**HOLISTIC OVERVIEW OF
GSI-191 RESOLUTION FOR KEWAUNEE POWER STATION**

**DOMINION ENERGY KEWAUNEE, INC.
KEWAUNEE POWER STATION**

**RESPONSE TO REQUEST FOR ADDITIONAL INFORMATION
GENERIC LETTER 2004-02**

RESPONSE TO REQUEST FOR ADDITIONAL INFORMATION KEWAUNEE POWER STATION

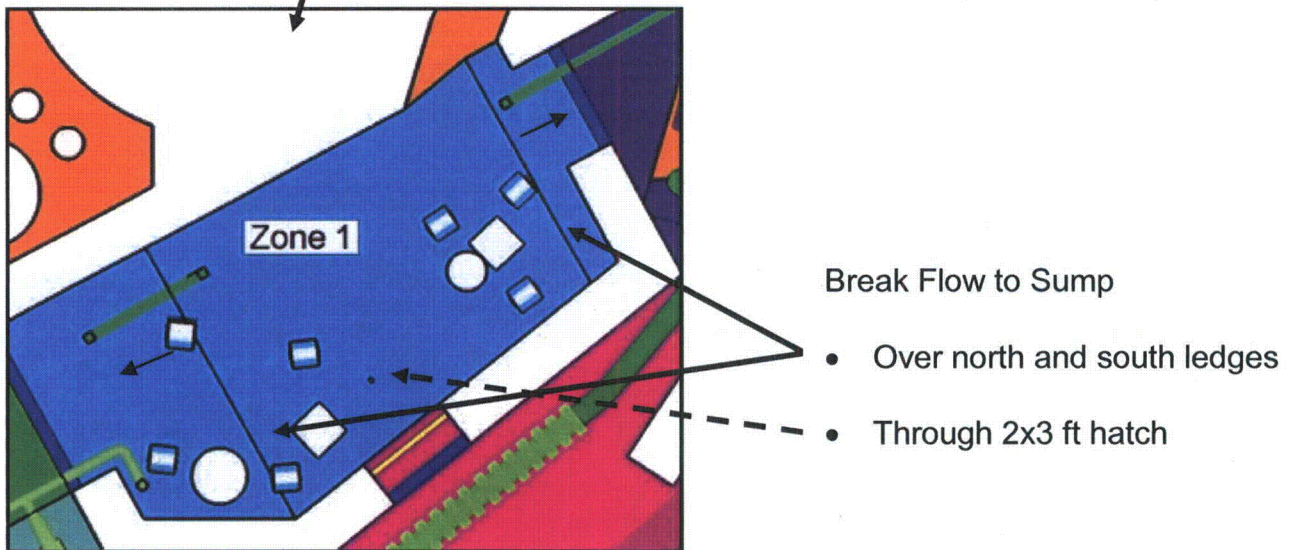
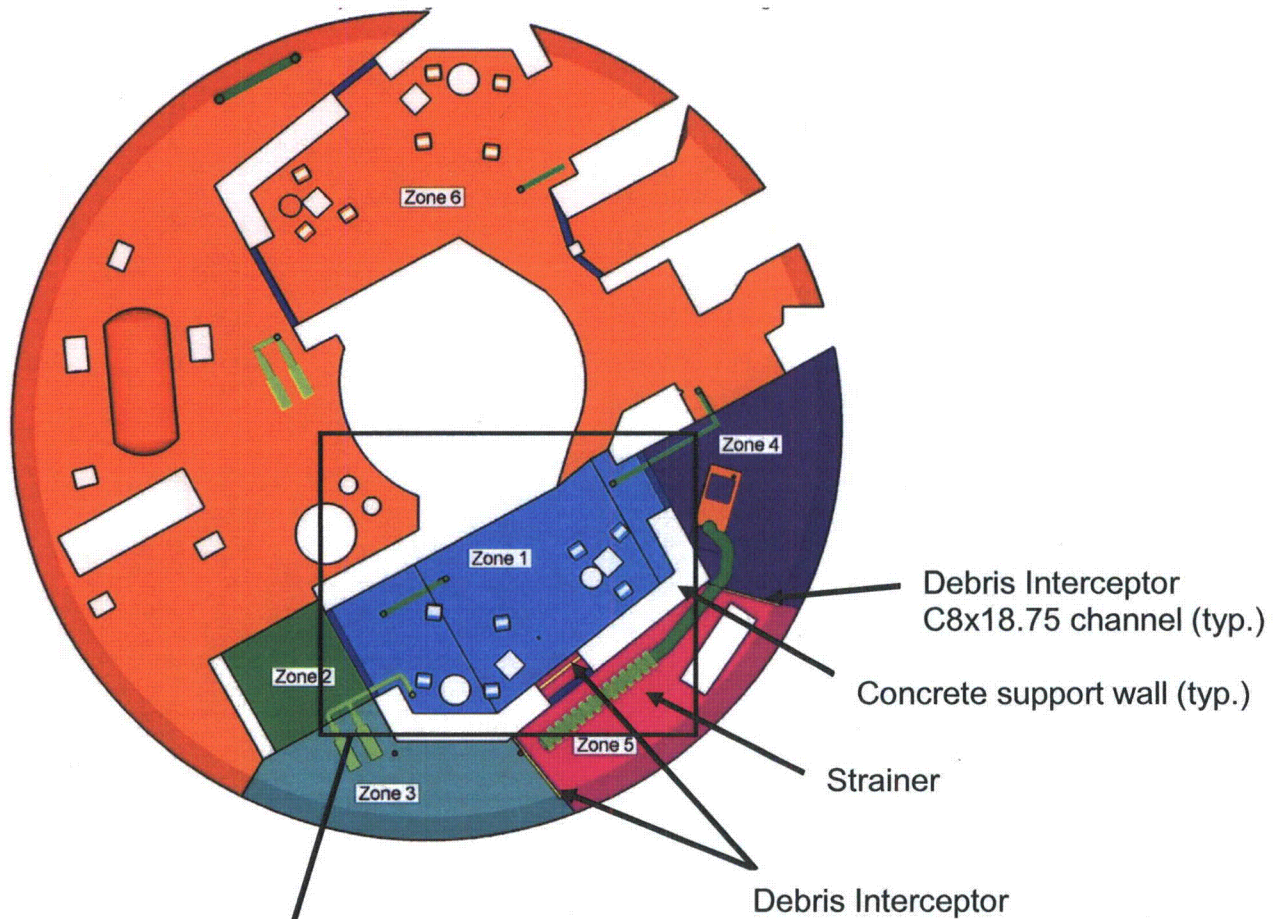
Please provide contour plots of the velocity and turbulence in the containment pool. Please also provide close-up plots of the velocity and turbulence contours in the region of the strainer and its immediate surroundings. In addition, please provide a table of the head loss test flume (average) velocity as a function of distance from the test strainer and the basis for the velocities chosen. Please identify the turbulence level simulated in the test flume and state the flume width(s) used for testing.

As indicated in Attachment 2 to this letter, and in response to Question 13, following removal of the fibrous insulation material on the pressurizer surge line pipe whip restraints and the Service Water piping in RCS Loop B Vaults, all remaining fibrous material in containment will be considered Fines and subject to transport to the strainer. DEK is no longer relying on the CFD analysis to determine the quantity of debris that will transport to the strainer. The total quantity of fiber from any generated break is limited to prevent the formation of a filtering bed of fiber on the recirculation strainer.

The pictorials on the following page display the layout of the containment sump. For the limiting break, RCS Loop B hot leg break at the Steam Generator (SG), the limiting break location is one elevation above Zone 1. RCS break flow exits the SG/Reactor Coolant Pump (RCP) vault and washes into the sump from three vault openings.

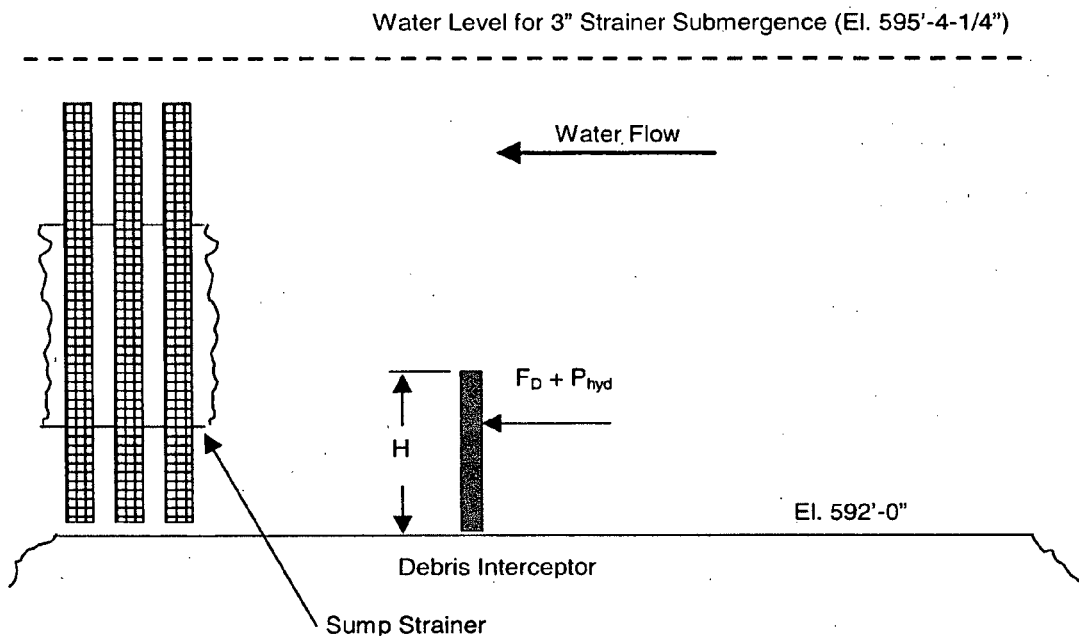
Figure 4 of the licensee's February 2008 supplemental response indicates that three debris interceptors were installed as part of Dominion Energy Kewaunee, Inc.'s GL 2004-02 resolution efforts. However, these components were not mentioned in Section 3.k of the supplemental response. Please provide additional information regarding the structural adequacy of these components including a description and summary of the structural analyses that were performed to demonstrate the ability of these components to maintain their structural integrity during a design basis accident.

The debris interceptors, C8x18.75 channel, were structurally evaluated for consideration of drag and hydrostatic loads, deadweight and seismic loads, including the inertia effects of the hydrodynamic mass during a seismic event. There are no dynamic loads on the debris interceptors from a postulated pipe break (no jet impingement or pipe impact).

The debris interceptors were evaluated for a minimum water level of 40.5 inches which bounds the minimum water level at the start of recirculation. Evaluation assuming minimum water level provides a more conservative drag load.

ANALYZED RCS COLD LEG BREAK – NOT LIMITING BREAK

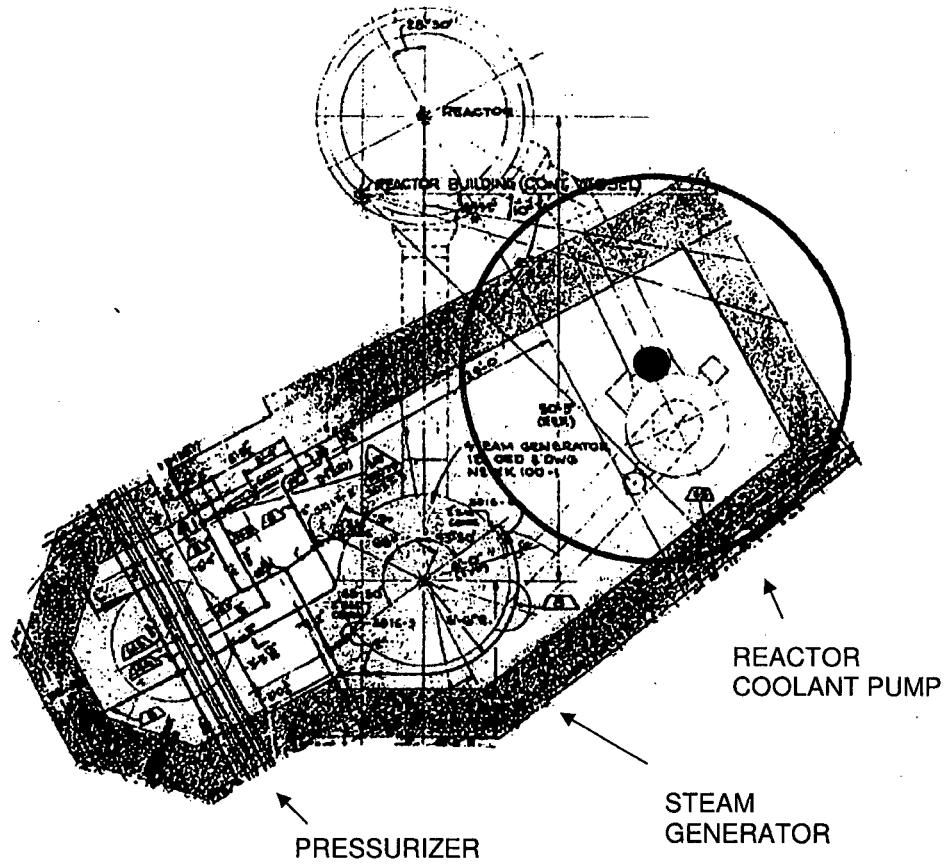
Please provide the following additional information regarding the break selection evaluation:

Due to the large zone of influence (ZOI) for the debris types present in these areas (see Enclosure A), additional RCS loop breaks were not analyzed as the debris source term would not change. The insulation debris materials involved in the RCS Loop B break include:
